City of Healdsburg

Addendum

Date:	Thursday, February 22, 2024
Project Name:	CIP 01-024 Municipal Recycled Water Pipeline Project Project WA004
Addendum No.	1
Issued To:	All plan holders

JOB NUMBER 700-30-22-16
DRAWING NUMBER D109
SHEET NUMBER 41 OF 43
REVISION

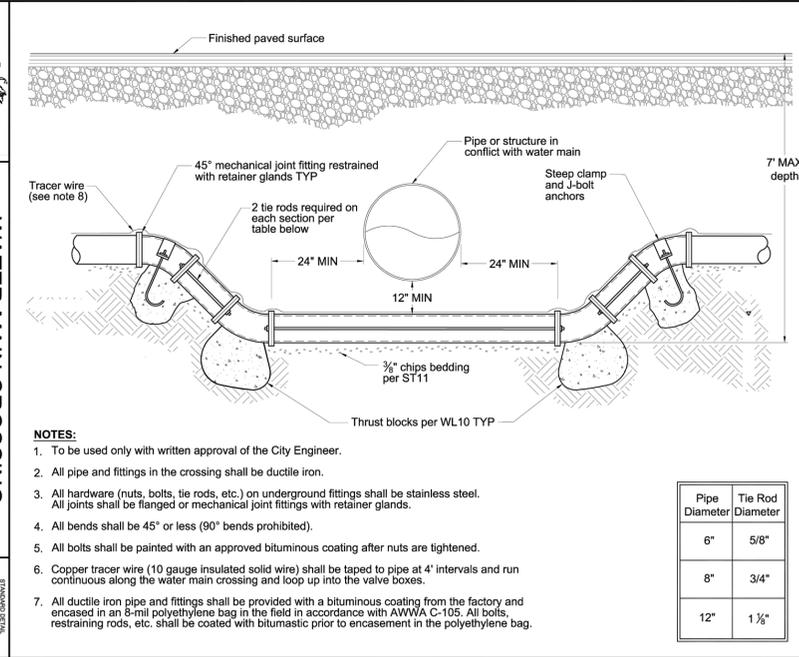
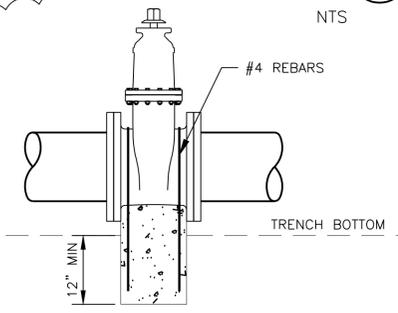
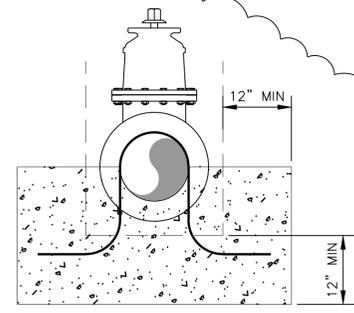
2.6 On Drawing G002, Note 35.f, , **REPLACE with the words**

2.7 On Drawing D109, **REPLACE this drawing with D109 attached to this Addendum 1.**

“f. ALL PIPE BENDS, TEES, CROSSES, REDUCERS, DEAD ENDS AND VALVES SHALL HAVE THRUST BLOCKS. THE THRUST BLOCKS SHALL BE IN ACCORDANCE WITH CITY OF HEALDSBURG PUBLIC WORK STANDARD DETAIL WL10, AND DETAILS 27 AND 28 ON DRAWING NUMBER D109 AS APPLICABLE.”
